November 13, 1991

ULNRC-2513

DOCKET NUMBER 88-1-100  
CALLAWAY PLANT  
CORE OPERATING LIMITS REPORT

FIGURE 2

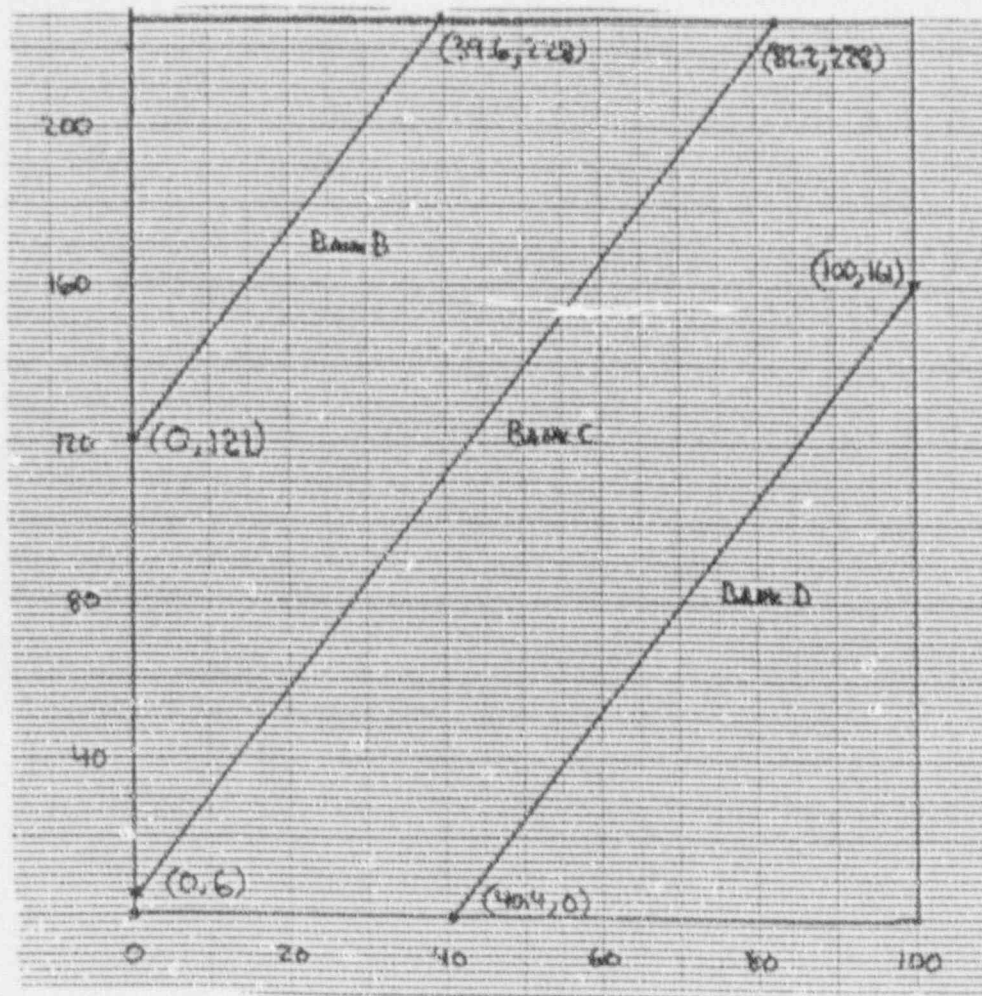
Attached, please find revisions to Figure 2 and Section 2.4.1 of the Callaway Cycle 5 COLR. Figure 2 provides a graph of the Rod Bank Insertion Limits versus Rated Thermal Power. This revised figure may be directly substituted for the current version in the Callaway Cycle 5 COLR and represents Revision 2 of this document. Section 2.4.1 specifies the Axial Flux Difference target bands applicable for burnup levels achieved from the date of this letter through the end of Cycle 5. The revised page 7 of 15 (attached) may be directly substituted for the current page 7 of 15 in the Callaway Cycle 5 COLR and represents Revision 3 of this document.
